## service bulletin

No. 93-19

## **Blackhawk Drive Applications**

## BOTTOM VIEW

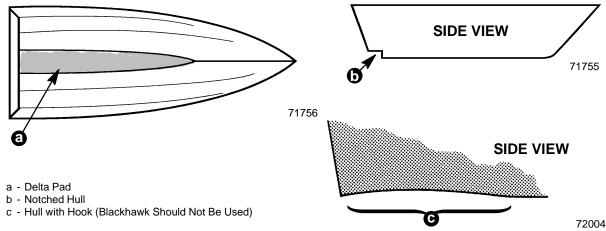
- The Blackhawk Drive is designed to operate with the propeller shafts running parallel to the water surface. The boat should be designed to run with a minimum wetted surface without porpoising at wide-open-throttle (W.O.T.). To achieve this, "Delta-Pads", "Notches", or "Steps" are often used.

- **Should Not** be used on boats that have a "Hook" in the back of the boat hull or that have "Lifting-Strakes" that run to the back of the boat (which would lift the stern of the boat and drop the bow).
